Planning Sub Committee - 6 March 2023

UPDATE FOR CONSIDERATION AT PLANNING SUB-COMMITTEE Item No.9

Reference No: HGY/2021/1909	Ward: Hornsey
Address: Cross House 7 Cross Lane N8 7SA	
The proposal description is amended (in bold) to correct the number of car parking space proposed as follows	
Proposal: Demolition of existing building; redevelopment to provide business (Class E(g)(iii)(light industrial) use at the ground, first and second floors, residential (Class C3) use on the upper floors, within a building of six storeys plus basement, provision of 6 car parking spaces and refuse storage.

Proposed 1st floor

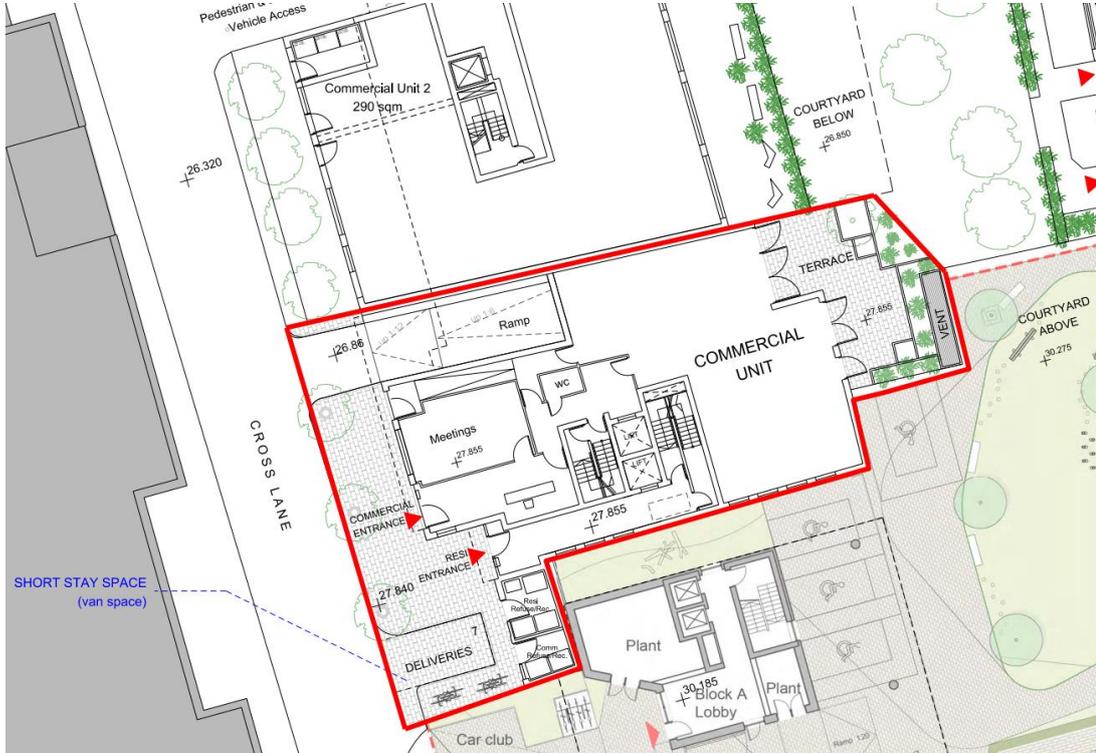
- Disruption from the car park entrance to local residents
- The first floor terrace is not set back or screened like Granita Courts terrace
- Noise and disturbance from the first floor terrace in a residential area
- Concerns the commercial units will have balconies
- Access to the terrace of the commercial property should be restricted
- The terrace should be redesigned

NEIGHBOURING PROPERTIES		
<p>1 further letter received</p>	<ul style="list-style-type: none"> - Disruption from the car park entrance to local residents - The first floor terrace is not set back or screened like Granita Courts terrace - Noise and disturbance from the first floor terrace in a residential area - Access to the terrace of the commercial property should be restricted - The terrace should be redesigned 	<p>The proposal will not result in any greater disruption from the car park than should be expected in an urban area.</p> <p>The 1st floor terrace would not result in a significant increase in overlooking to neighbouring properties</p> <p>The proposal will not result in any greater noise or disturbance from the first floor terrace than the current situation.</p> <p>The first floor terrace would not have a significant impact on neighbouring properties</p> <p>The design of the first floor terrace is considered appropriate</p>
